Additional Application Information

24-113646 | 383, 453, and 503 Farm Credit Drive

FARM CREDIT HOTEL

FARM CREDIT DRIVE SE
SALEM, OREGON

PLANTING PLAN

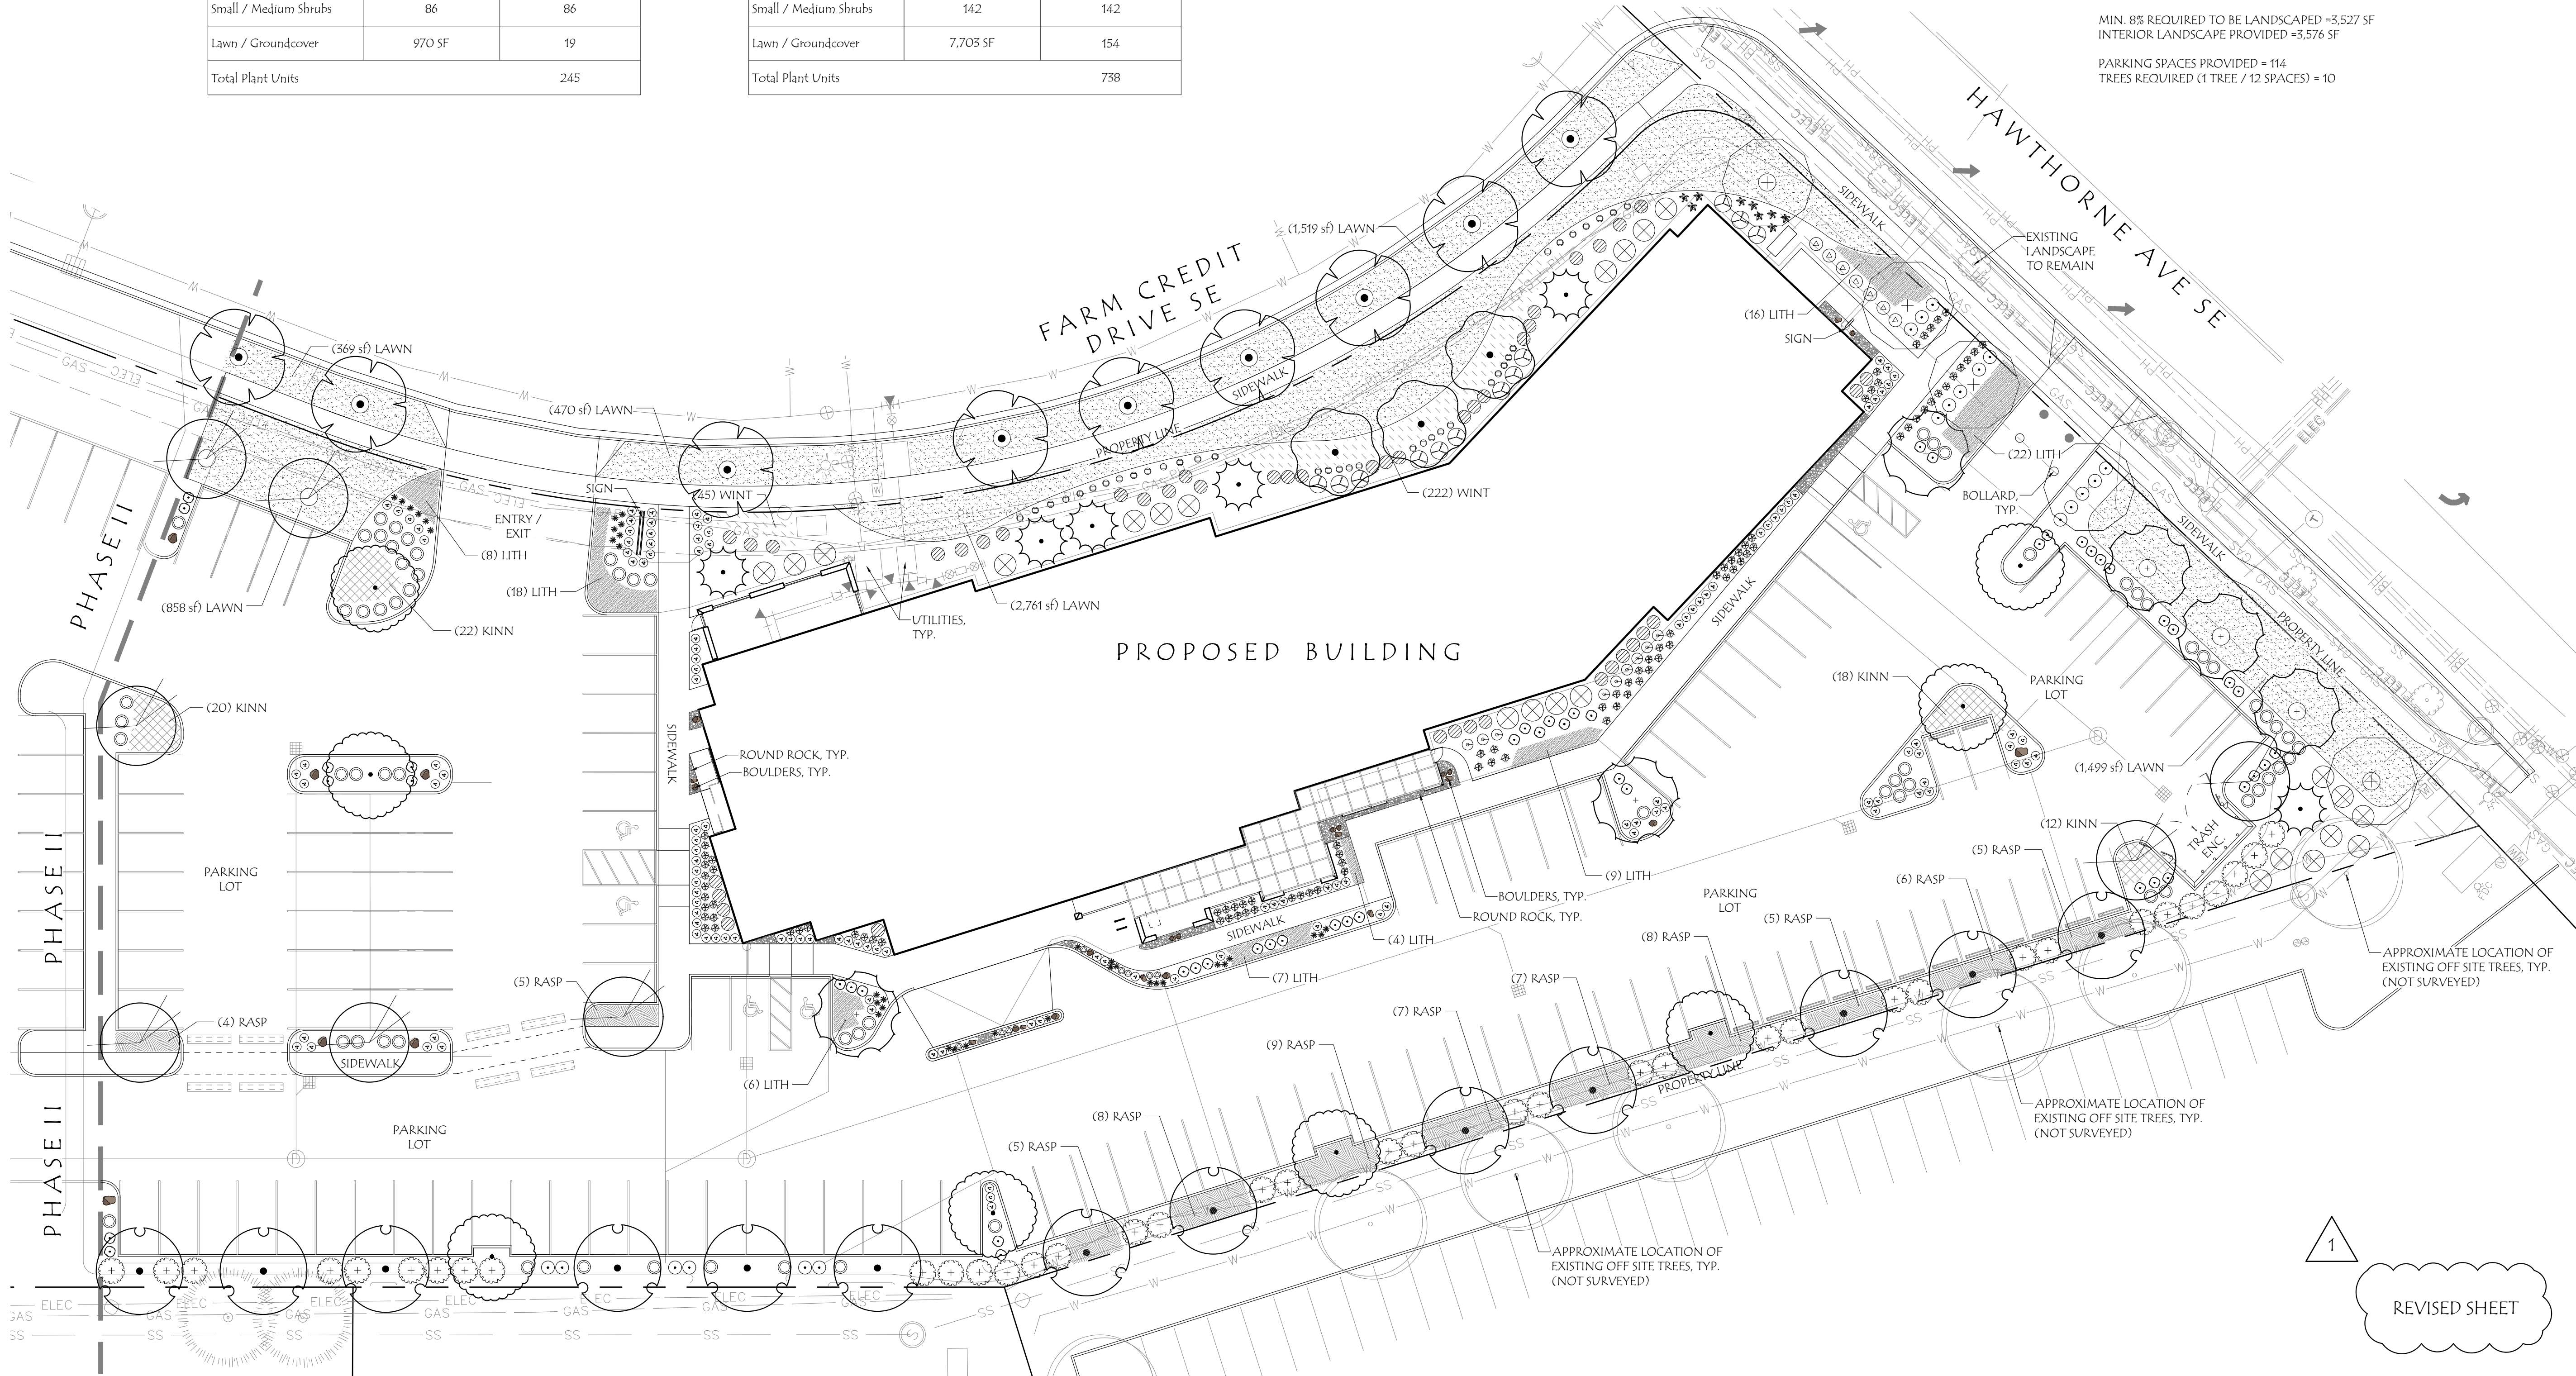
Our team has revised the parking stalls which abut the internal property line to be compact spaces. These updates are provided on the revised plans included with this letter. The revisions allowed the installation of a 3.5' planter with a 6" curb on each side of the property line for a total planting area of 7' in width and a 4' total setback on each side of the line. While this does not prescriptively meet the development standard, the inclusion of the landscape buffer meets the intent by providing separation along the boundary and breaking up large spans of pavement. Our team believes an additional condition of approval to provide the displaced plant units (the number of additional plant units which would be planted here if the standard was met) within Phase 2 bolsters our proposal and meets the intent of the standard. If you agree with these revisions, we believe Conditions 25 and 26 could be eliminated and replaced by a new condition to include the displaced plant units within the landscaped area of Phase 2.

TREE CANOPY
PLAN

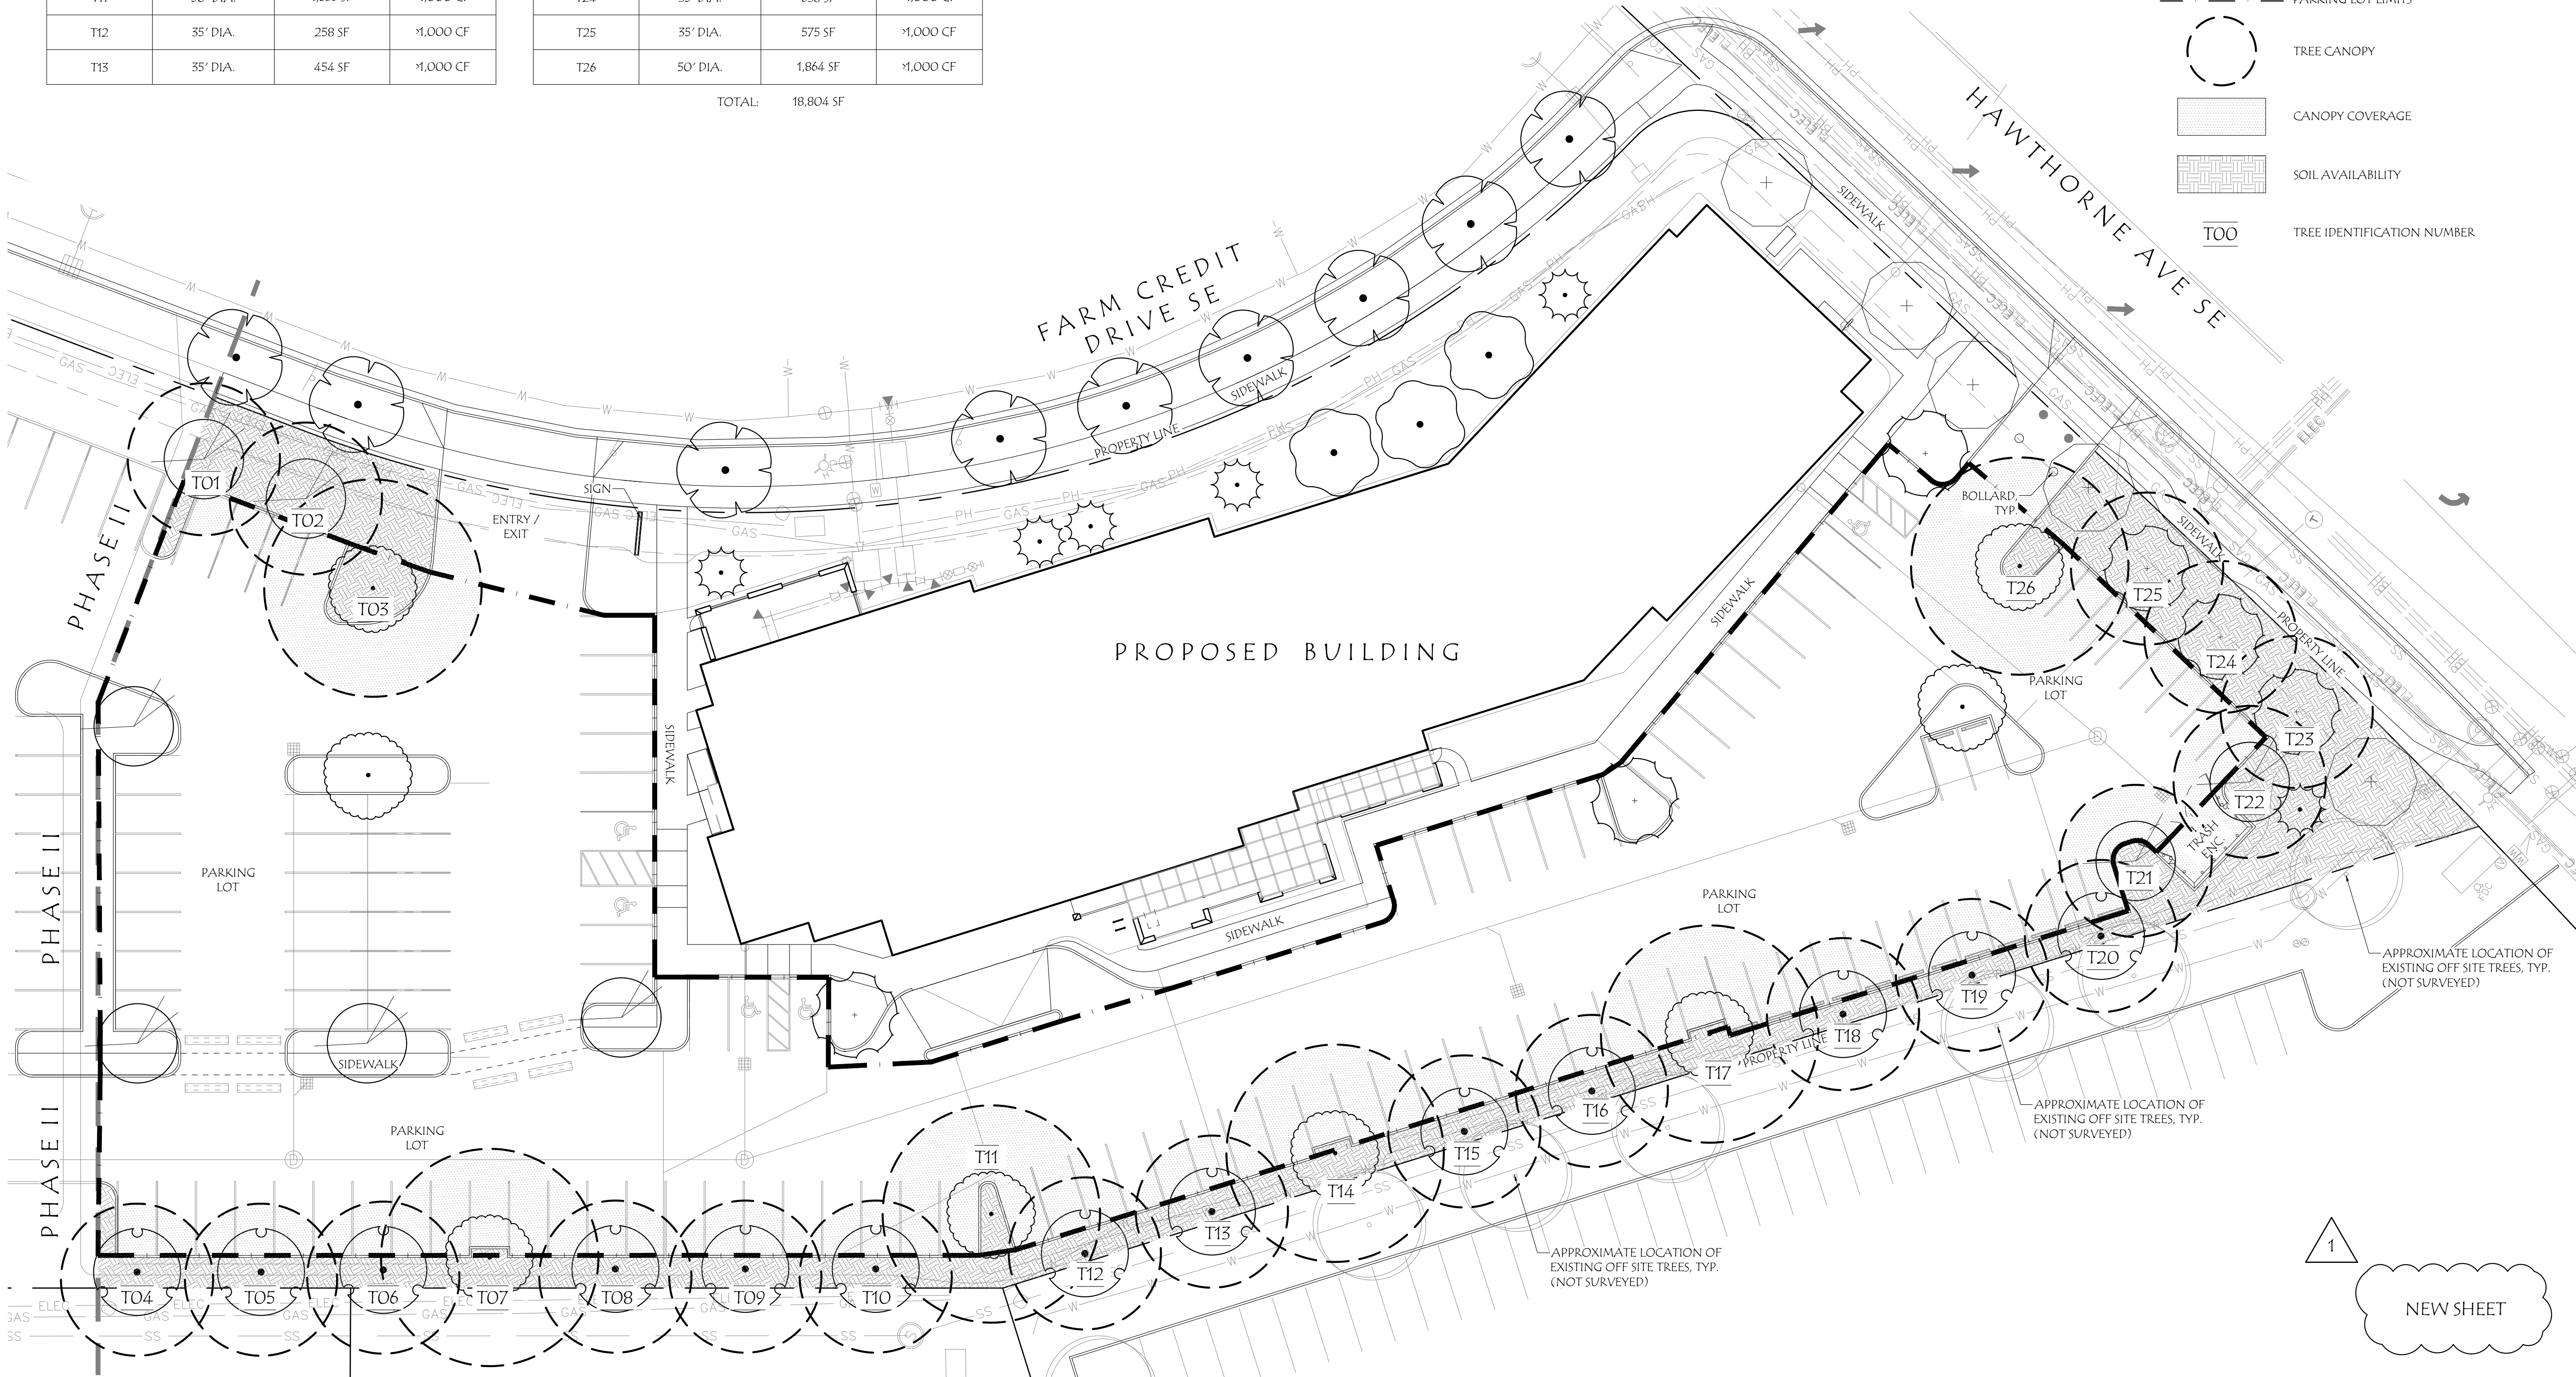
Our team has worked closely with the landscape architects to prepare detailed landscape plans demonstrating the requirements are met and a condition to pay the fee in lieu is no longer necessary. As demonstrated on the plans provided, the tree canopy coverage will exceed the 40 percent requirement by roughly 800 square feet. Additionally, soil volume calculations have been added to tables on the landscape plans. Upon your review and acceptance of our updated plans, we hope to see the elimination of Condition 16, which requires a fee in lieu of meeting the standard. We believe Conditions 17, 18 and 19 can remain as stated, but ask for confirmation that you agree we've demonstrated compliance.

PARKING LOT SF: 45,006 SF
40% PARKING LOT SF = 18,002 SF
TREE CANOPY PROPOSED: 18,804 SF
